TO: UTC
FROM: Deborah Anderson, Ken Whistler, Roozbeh Pournader, Andrew Glass,
Laurentiu Iancu, Lisa Moore, Liang Hai, Richard Ishida, Karan Misra, and Rick
McGowan
SUBJECT: Recommendations to UTC #150 January 2017 on Script Proposals
DATE: 21 January 2017

The Script Ad Hoc group met on 2 December 2016 and 17 January 2017 in order to review proposals. The following represents feedback on proposals that were posted in the Unicode document registry at the time the group met.

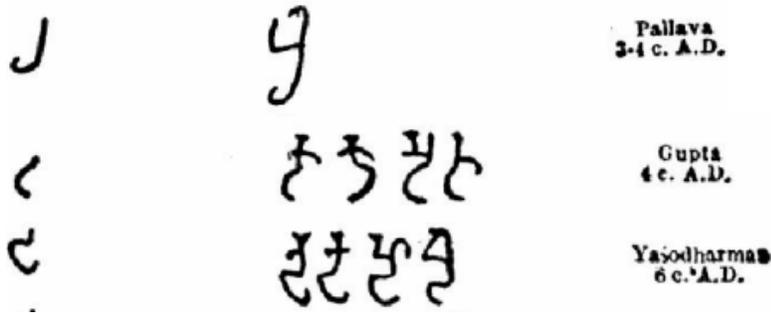
Comments: We reviewed this document, which requested a glyph change for two Brahmi vowel signs, U+1103E VOCALIC R and U+1103F VOCALIC RR, to glyphs that reflect the earliest attestations (1c CE).

As noted in the proposal, the current glyphs represent the vowel signs of the northern variety (from ca. 4c CE) that had evolved and changed direction from a curve to the left to a curve to the right. The southern variety had a leftward curve.

While the examples demonstrate that the current glyphs, which curve to the right, should be changed, it was not clear what the representative shapes should be. The glyphs appear most frequently to be downward curved shapes, but the proposed glyphs are horizontal.

We suggest the authors provide more analysis, discussing how scholars analyze figures 6 and 7, and provide more convincing examples. Also, for greater clarity, put a square around the vowel sign and identify the base letters in figures 3, 4, and 5.

Recommendations: We recommend the UTC review this document, and forward comments to the proposal author.

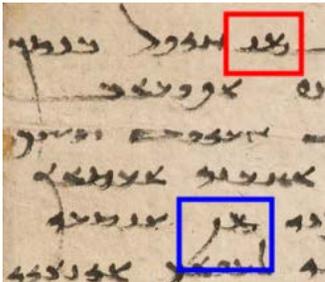
- In the figures, the use of final forms vs. final forms with swashes appears to be based on the character’s placement on the page or due to scribal idiosyncrasies. Can evidence be provided that shows the usage has a semantic basis, and is not just stylistic? Compare the FINAL NUN (green) and FINAL NUN WITH VERTICAL SWASH (blue) in figure 8:

In figure 14, the same word appears in one place with FINAL NUN and the other with VERTICAL SWASH. Do they mean different things, or is the difference stylistic?

Based on these examples, we recommend the author remove the final forms with swashes (TAW, SADHE, and NUN), and close the gap in the code chart.

Recommendations: We recommend the UTC review this document. With the changes made above, we would recommend the UTC approve the encoding of Old Sogdian.
